PORTION 91 OF FARM MATJESFONTEIN NO.304

RESPONSE TO COMMENTS AND OBJECTIONS RECEIVED

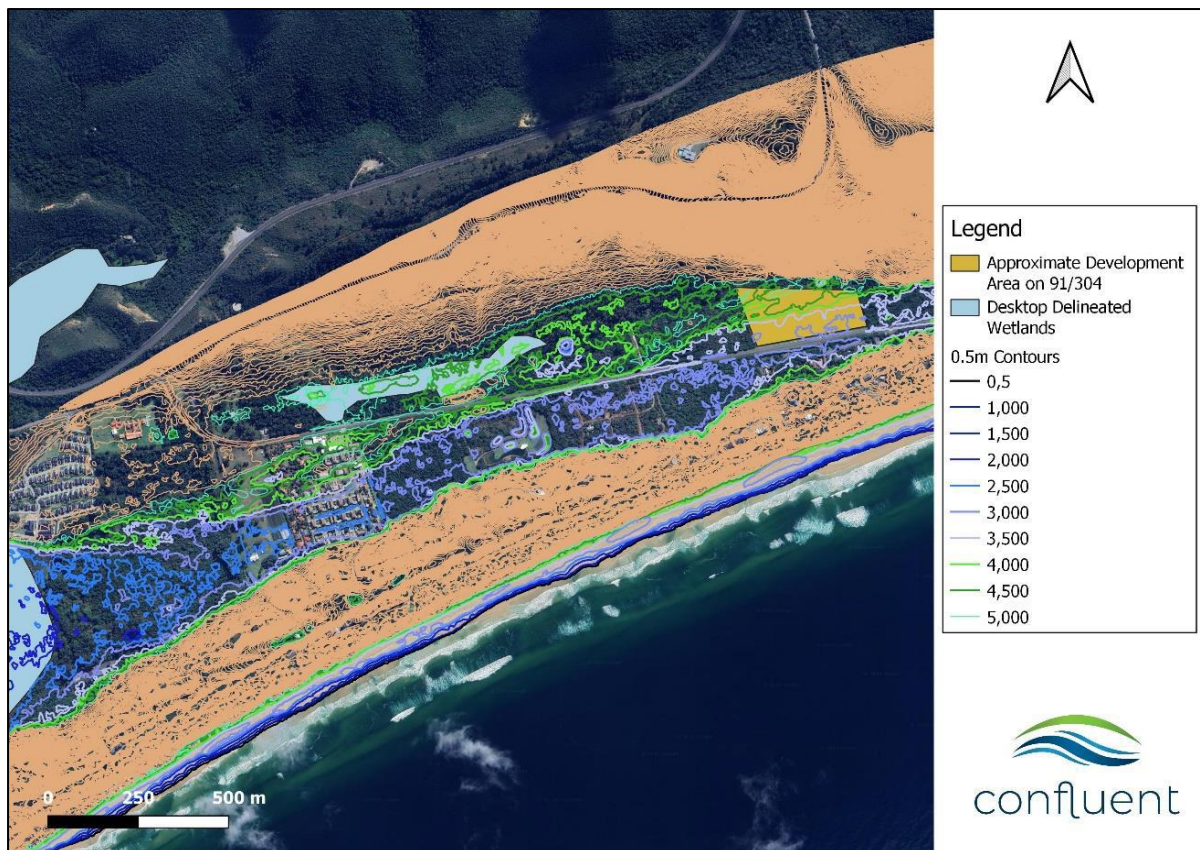
Concerns were raised that, due to the low-lying nature of the site (below 4.5m above the MSL) as well as being within the mapped Estuarine Functional Zone, there is a risk of flooding to the property, which could also enlarge the risk of flooding of surrounding properties.

The 0.5m Contour Plan for the areas indicates that The Dunes development is generally at 2.5 mamsl while everything east of this area is at 3.0m or higher. The 3m–3.5m contours are concentrated on the southern side of the Keurbooms Road and only extend over a very small area of the proposed development area, close to the road.

As mentioned before, the road itself acts as a barrier at 3.65m between the south (where any flooding would originate) and the north (the development area). It can be seen from the figure below that any floodwaters from the Keurbooms would theoretically move east, but remain mostly south of the Keurboomstrand Road. During severe flooding in the area in 2007 the highest level reached by floodwaters was The Dunes development at around 2.5m amsl, about 1.1km west of the property.

The Contour Plan confirms that any flooding would come from the south (Milkwood Glen side) and move towards Portion 91, not the other way around. But this would likely be stopped by the road. This is most likely why the 1:100-year flood line is indicated as stopping south of the road. The proposed development can, therefore, not result in the flooding of the surrounding area.
